Recall Service Bulletin RSB23-330-001

APPLIES TO: This service bulletin applies to certain 2021 through 2024 model year, Gladiator, Metro Star, FC-94, KME Panther, and KME Predator model emergency response chassis cabs built between June 2022 and September 2023.

CONDITION: Potential delay in the park brake setting after park brake valve is activated.

CORRECTION: Inspect and replace the inversion valve if qualified.

Figure 2.1

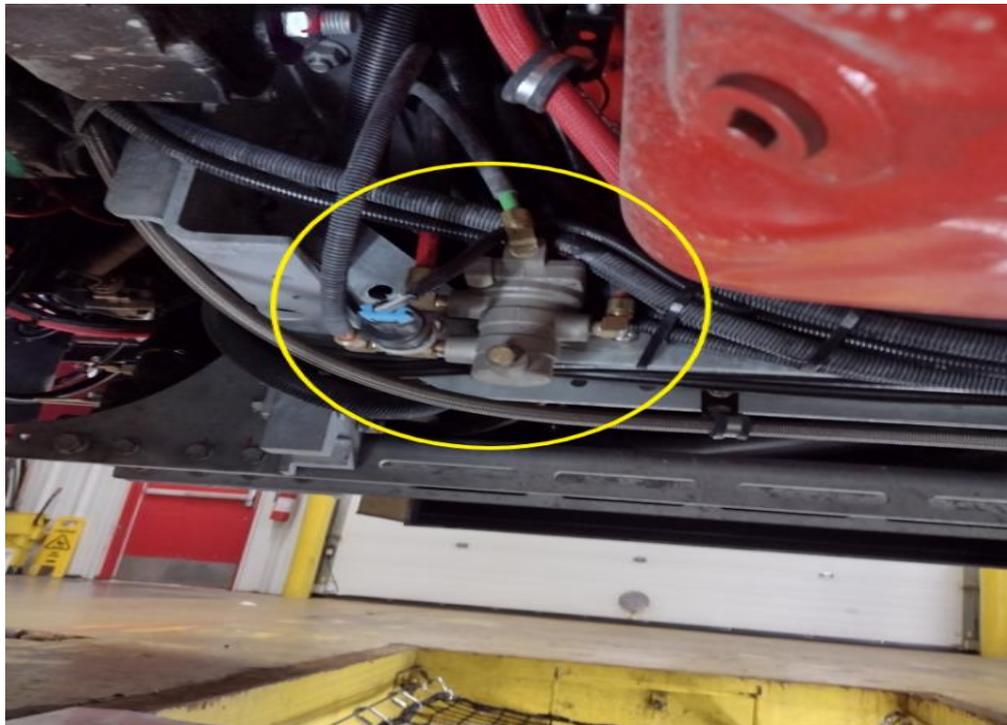
- 1) Ensure vehicle park brakes are set and chock the wheels.
- 2) Locate inversion valve under truck mounted to the crossmember in front of the engine on the driver's side. (See Figure 2.1)

Figure 5.1

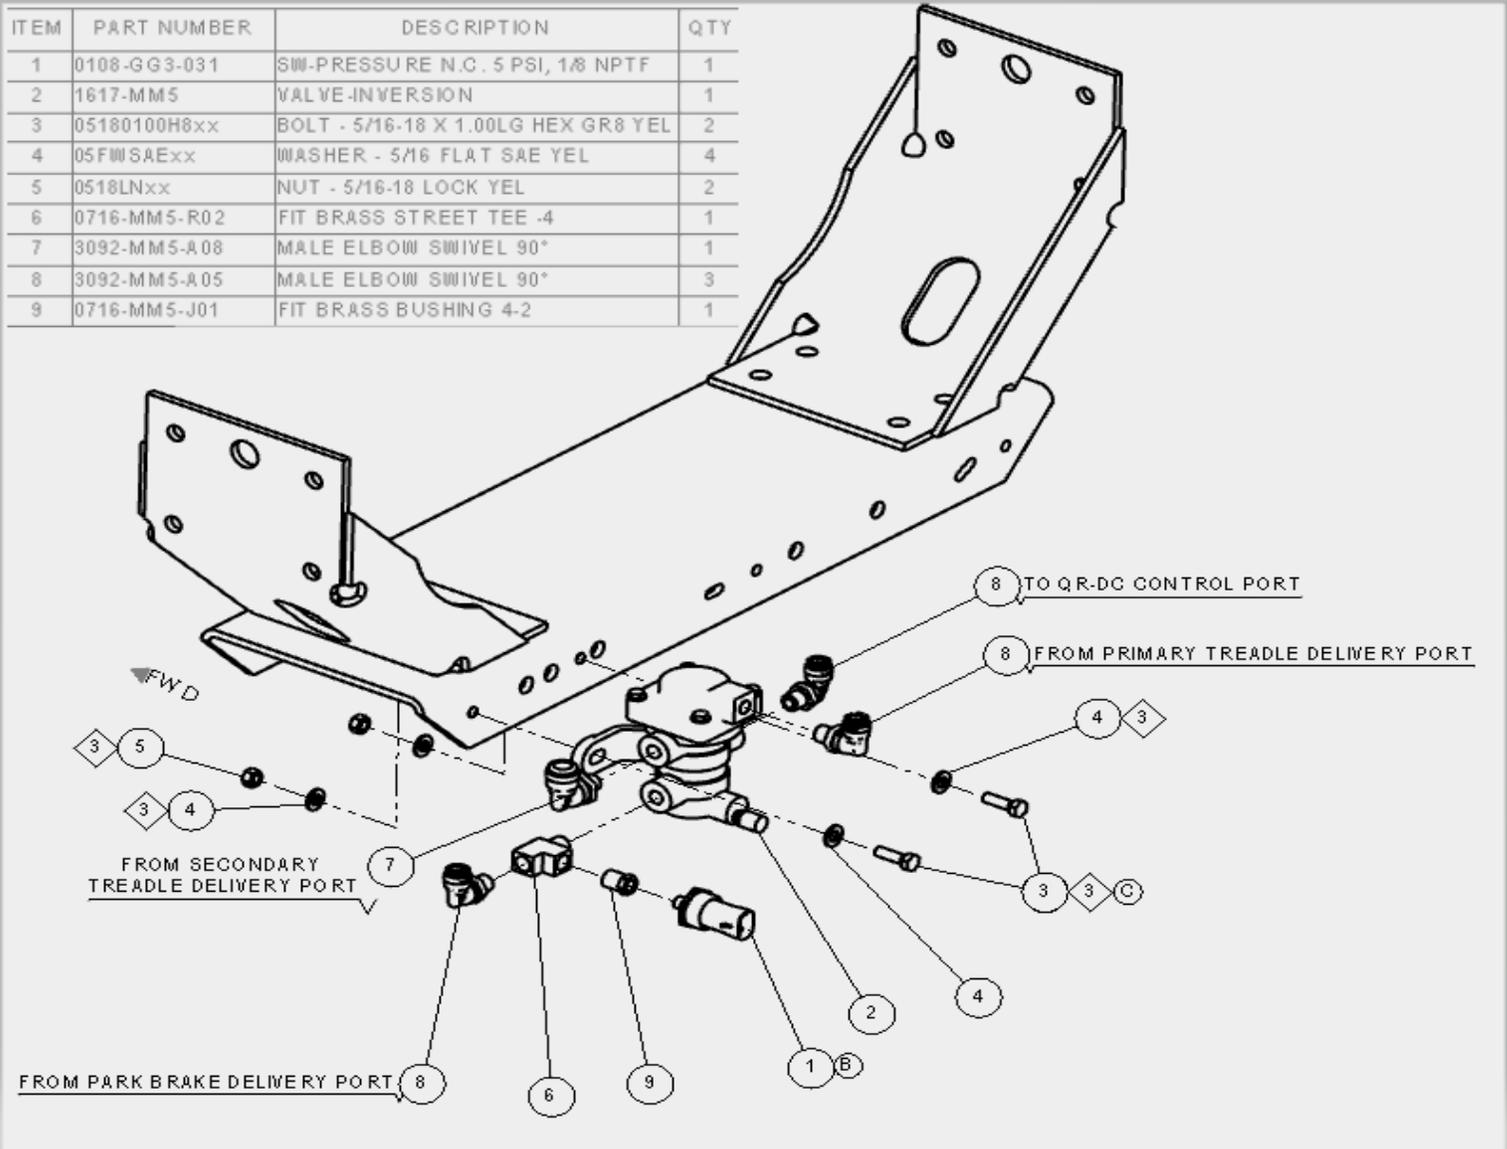
- 9) Install new inversion valve to cross-member using same two 5/16" bolts.
- 10) Reconnect air lines in their respective locations. (See Figure 5.1 and 6.1)
